17693-L-001	Transmittal of Oyster Creek Drywell Review Report, Rev. 0	4/6/09	GLH
-------------	---	--------	-----

## NJDEP Oyster Creek Drywell Review

Document No. 17693-R-001

Figure 3.1  
Thinned Region Eccentric Modeling Comment

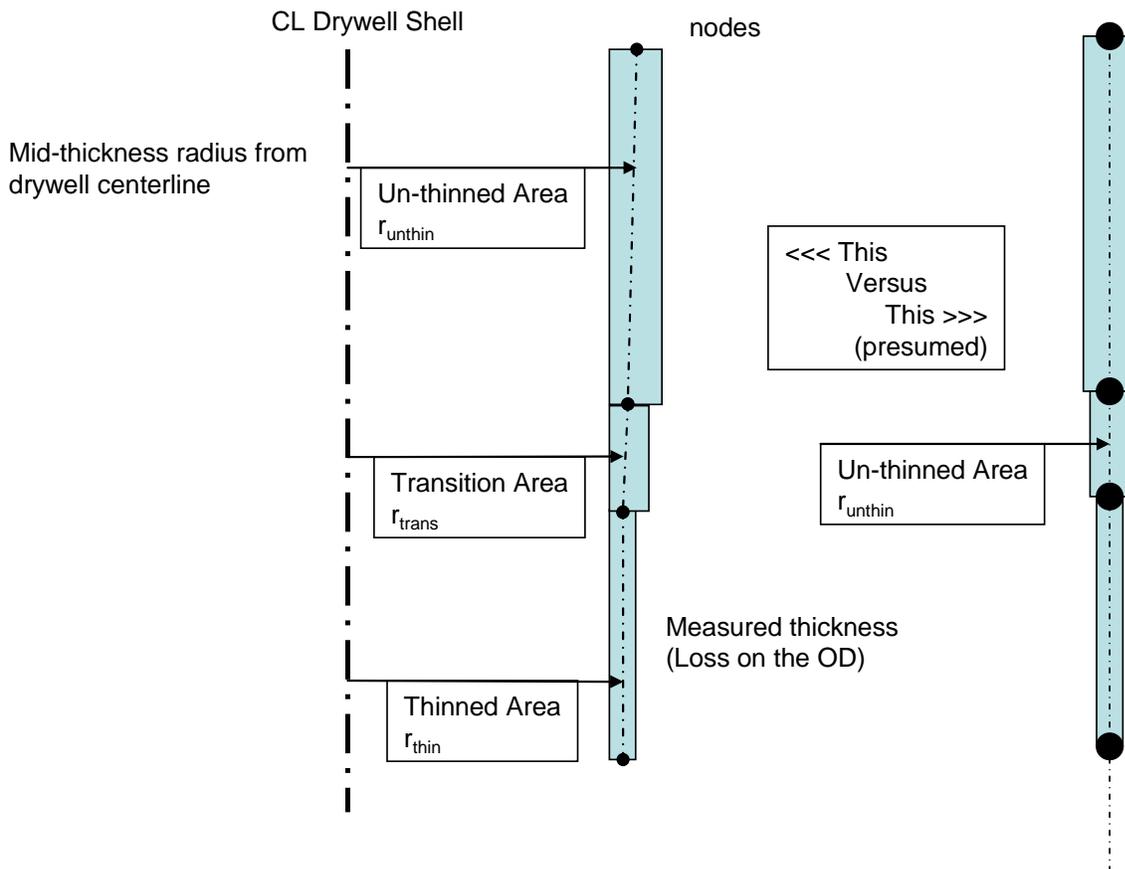
3.1 The Thinned Region Modeling Eccentricity Comment. Regarding the comment in Table 2.3, for the 403 Report, pg 4-3, Figure 3.1 is provided as a supplemental description.

**Figure 3.2**  
**Modified Capacity Reduction Factor for Tensile Hoop Stress (Fig. 8-7a of SIA’s 403 Report [1])**

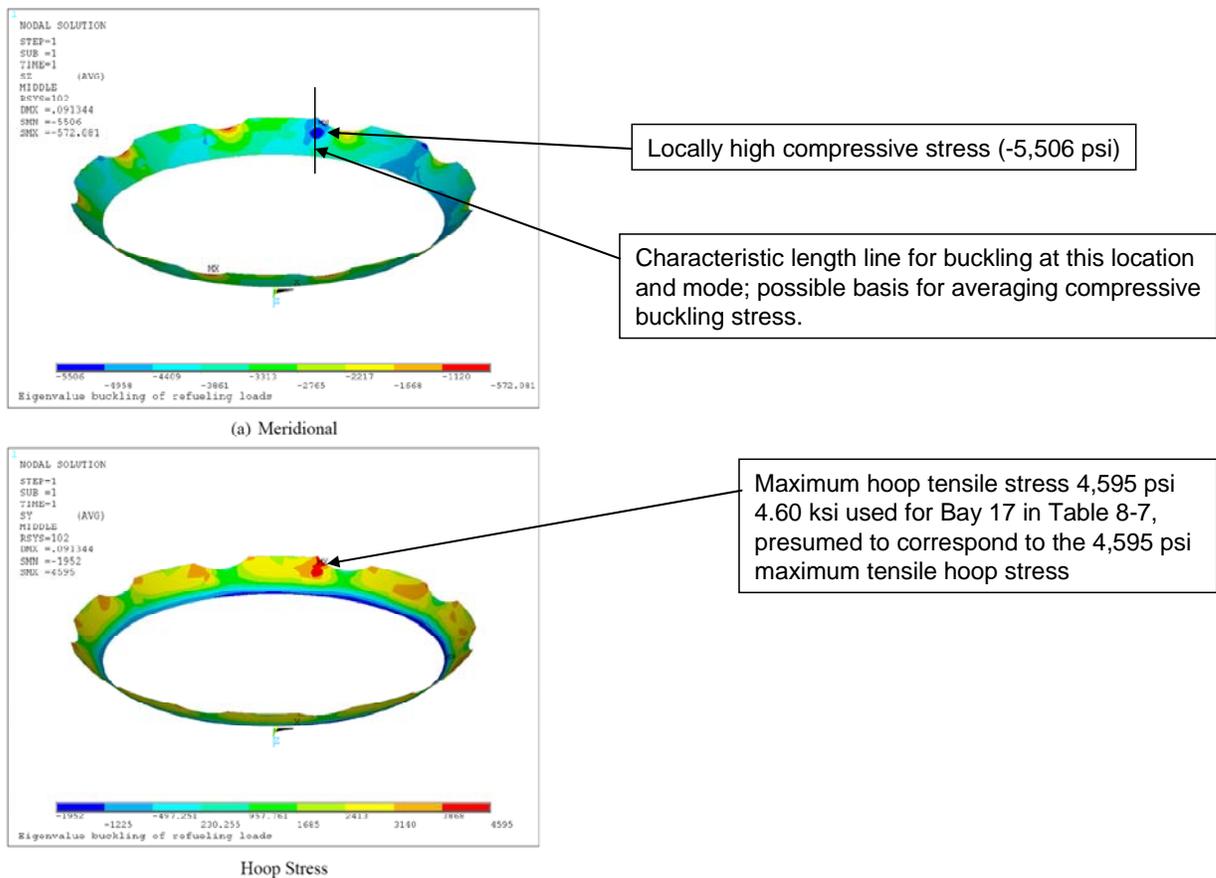
Figure 3.2 shows a case where the maximum compressive and maximum tensile stresses are approximately at the same location. Both the compressive stress and hoop tensile stresses are high (absolute values) in a local region – the blue circular region and the red circular region in Fig. 3.2. BNS believes that such a condition is not one that clearly justifies the use of the hoop tensile stress modified CRF, as SIA has done. Nonetheless, it may be possible to define an appropriate local characteristic length to mitigate the effects of taking the locally highest value of compressive stress. A portion of that line may be used over which to average compressive buckling stress. Similarly, it may be possible to define an appropriate hoop-direction local characteristic length to assure that an adequate region of hoop tension exists to provide the purported benefits of hoop tension on the CFR.

**Figure 3.3**  
**Modified Capacity Reduction Factor for Tensile Hoop Stress (Fig. 8-9a of SIA's 403 Report [1])**

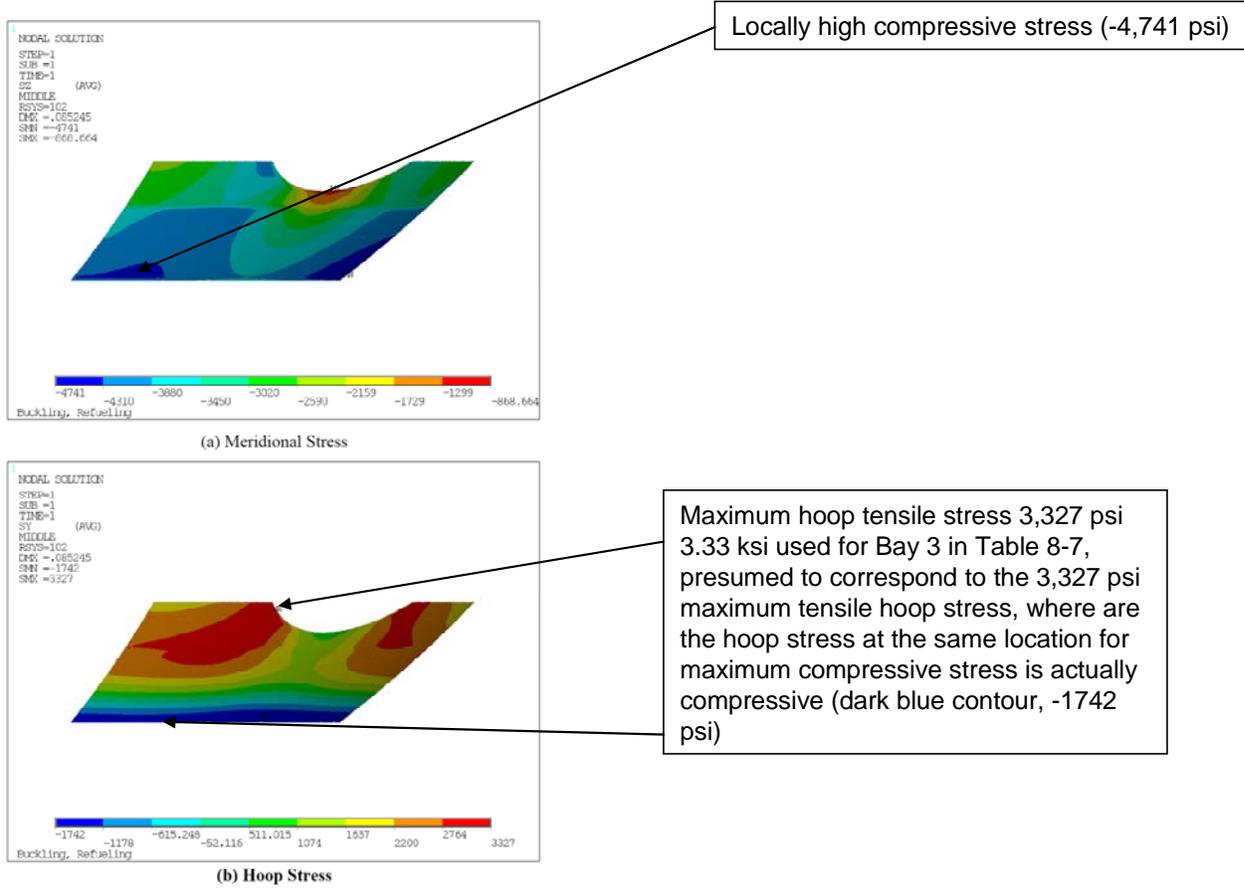
Figure 3.3 shows a case where the maximum compressive and maximum tensile stresses are not at the same location, which BNS believes would not qualify for using the modified Miller equation [23].
